Berlet Site Plan Review

ACTIVITY #: PL20240057

PETITIONER: Berlet Roofing
PETITION: Site Plan Review for a single family residence with attached garage and Home Occupation use
LOCATION: 38980 Main St (Milner)
ZONE DISTRICT: Commercial (C)
AREA: 0.22 acres
STAFF CONTACT: Michael Fitz – mfitz@co.routt.co.us
ATTACHMENTS:

1 SITE PLAN 11X17
1" = 20'-0"

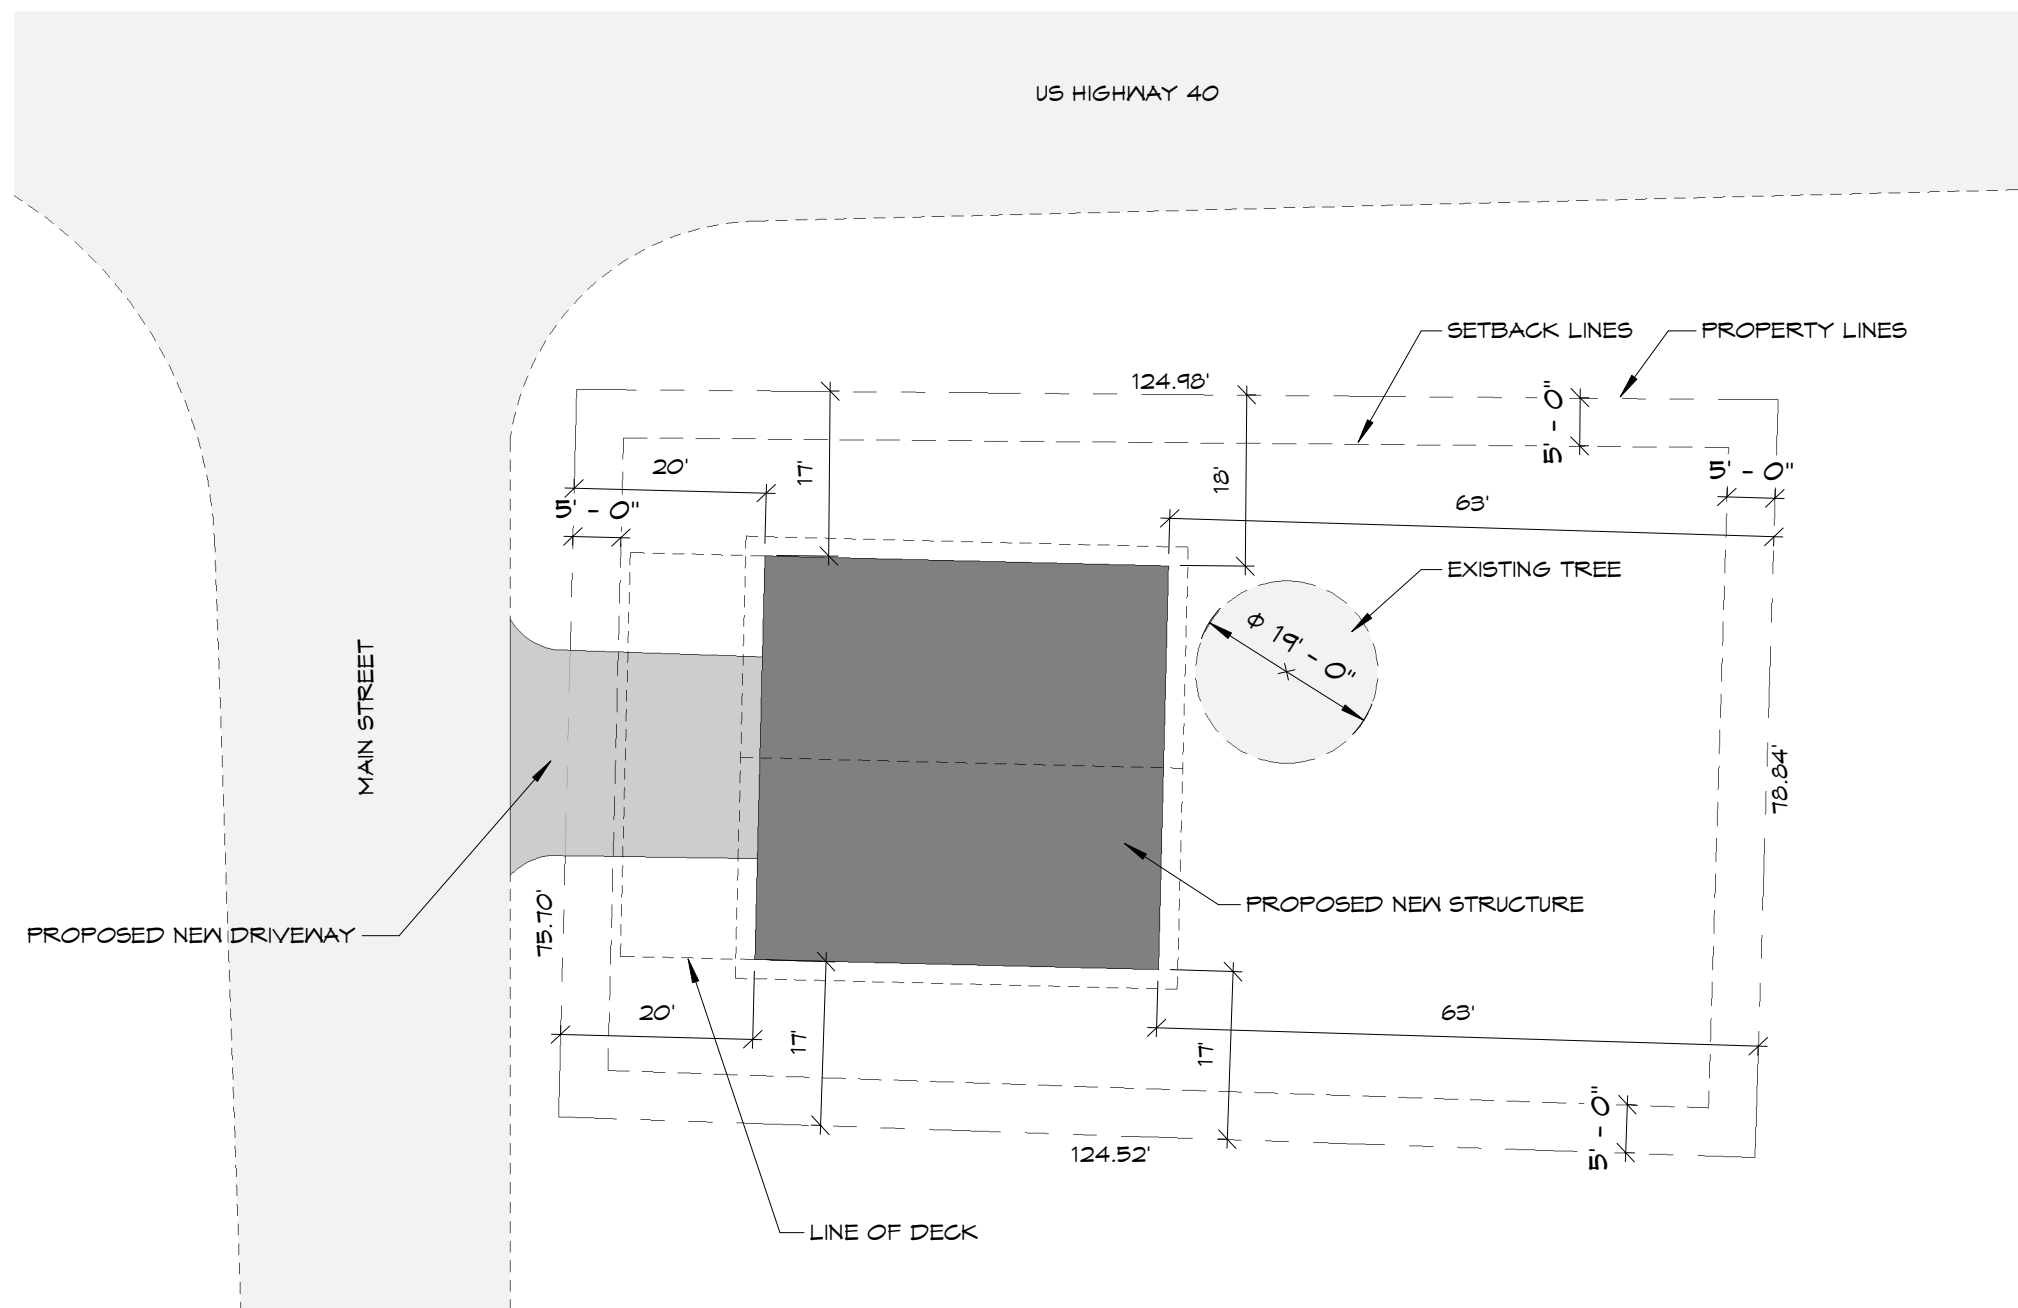
Staff comments: The proposal complies with all general provisions in Section 3.1, as-applicable. Employee Housing, Public Benefit, and Essential Housing requirements are not applicable for a single-family home being reviewed under a Site Plan Review. While Section 3.20.A.3 requires rear (alley) access when possible, the alley adjacent to this site is not maintained by the County and is also prohibited by CDOT from connecting to US 40, so the Public Works Department is supportive of a front access onto Main St. The application does not comply with 3.20.A.5 requiring pedestrian facilities, and the applicant has requested a variance to this standard, detailed below. Staff is supportive of the request.

The applicant has requested a Variance to Section 3.20.A.5, which states “Pedestrian facilities are required in all developments through the provision of sidewalks or trail

connections. Separation of pedestrian and bicycling improvements from vehicular traffic, through a landscape buffer or setback, are encouraged to support safe walking and biking opportunities. Trail facilities can be hard- or soft-surface”.

Staff Analysis: Supportable. Standard 3.20.A.5 is intended for larger developments, such as commercial uses, larger subdivisions, or resubdivisions, where sidewalks are necessary to mitigate the impact of increased traffic and density in Milner. One additional single-family home does not create this impact. The standard would ordinarily not apply on residentially-zoned lots, but this home requires a Site Plan Review, triggering Chapter 3 standards, because the property is zoned Commercial.

Staff recommends that the application be **APPROVED**.
